LLFA DRAINAGE COMMENT / QUERY TRACKER - 14.08.2020

This tracker has been compiled to provide a detailed response to comments received by Camden Planning from the Lead Local Flood Authority in relation to the proposed development.

Pond Catchment Area (based upon Lidar)

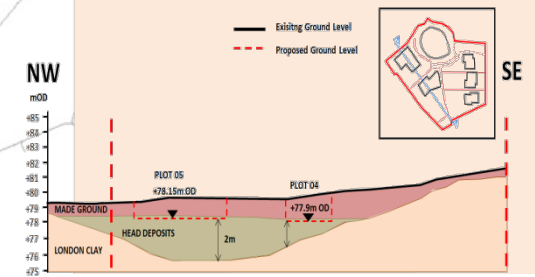
There is an obvious mismatch between the assessed run-off for this sizeable catchment area and the observed volume of flow (<1litre/sec) seen trickling across Millfield Lane from the pond outfall. The answer lies in the detailed geology that has been established as below.
